# UNITED STATES PATENT AND TRADEMARK OFFICE

APPLICATION NO.	FILING DATE	FIRST NAMED INVENTOR	ATTORNEY DOCKET NO.	CONFIRMATION NO.
10/711,326	09/10/2004	Takahiro Nakano	SIC-04-034	5325
29863	7590	07/10/2008	EXAMINER	
DELAND LAW OFFICE P.O. BOX 69 KLAMATH RIVER, CA 96050-0069				IRVIN, THOMAS W
ART UNIT		PAPER NUMBER		
		3683		
			NOTIFICATION DATE	
			DELIVERY MODE	
			07/10/2008	
			ELECTRONIC

<b>Office Action Summary</b>	<b>Application No.</b>	<b>Applicant(s)</b>	
	10/711,326	NAKANO ET AL.	
	<b>Examiner</b>	<b>Art Unit</b>	
	THOMAS W. IRVIN	3683

## **DETAILED ACTION**

Figs. 1 and 2 (US Patent 3,168,836)

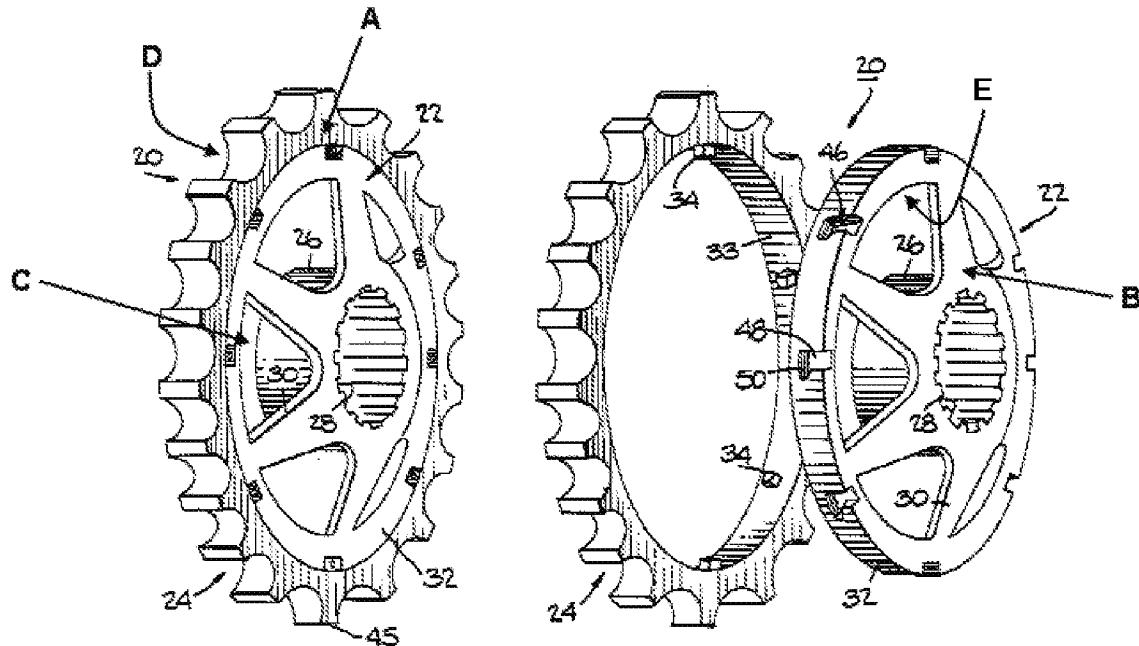
In Re claim 1, with reference to Figs. 1 and 2 shown above, Militana discloses a sprocket, wherein the sprocket comprises: a sprocket body (20); a plurality of teeth (45) extending radially outwardly from the sprocket body; a spline (28) extending radially inwardly from the sprocket body; wherein the spline includes a radially outer surface (26) facing radially outwardly; and wherein the radially outer surface of the spline faces a radially inner surface (E) of the sprocket body.

In Re claim 5, the sprocket body has a side wall that includes a first side wall portion (A) and a second side wall portion (B), wherein the plurality of teeth extend

radially outwardly from the first side wall portion, and wherein the second side wall portion is laterally offset from the first side wall portion.

In Re claim 6, the second side wall portion overlaps the outer surface (26) when viewed in a direction parallel to the rotational axis.

In Re claim 7, the second side wall portion is spaced apart from the first side wall portion in a direction of the rotational axis.

In Re claim 8, the spline is offset from the first side wall portion in a direction of the rotational axis.

In Re claim 9, the spline extends from the second side wall portion and terminates at a free end (C), and the free end is spaced apart from a first side wall (D) of the first side wall portion (A) that faces in a same direction as the free end.

In Re claim 10, the sprocket body has a side wall that includes a first side wall portion (A) and a second side wall portion (B), wherein the plurality of teeth extend radially outwardly from the first side wall portion. It is the examiner's understanding that the second side wall portion and the spline together form a composite spline.

In Re claim 11, a thickness of the spline in a direction of the rotational axis is greater than a thickness of the second side wall portion in a direction of the rotational axis.

In Re claim 13, with reference to Figs. 1 and 2 shown above, Militana discloses a bicycle sprocket, wherein the sprocket comprises: a sprocket body (20); a plurality of teeth (45) extending radially outwardly from the sprocket body; a spline (28) extending radially inwardly from the sprocket body, wherein the spline has a root portion (30) and

a radially inner portion (26), wherein the root portion extends radially inwardly of the sprocket body and has a side wall (B) facing in a rotational direction, and wherein the radially inner portion extends radially inwardly of the root portion and has a side wall (C) facing in the rotational direction; and wherein a thickness of the radially inner portion of the spline in a direction parallel to the rotational axis is greater than a thickness of the root portion of the spline in a direction of the rotational axis.
